Appl. No. 10/760,139

REMARKS

FIGURE 3

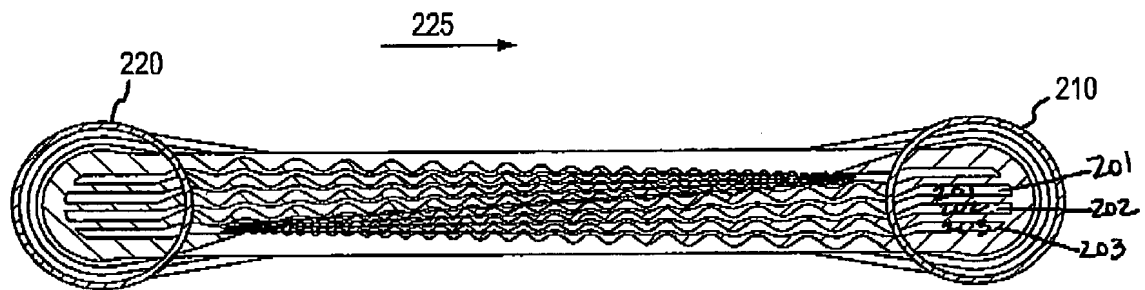
Applicants note the Examiner's objection to Figure 3 and has attached a new Figure 3 containing the inadvertently omitted reference numbers.

Attached is one annotated drawing sheet showing changes to Fig. 3. Also enclosed are 4 replacement drawing sheets for Figs. 1-4.
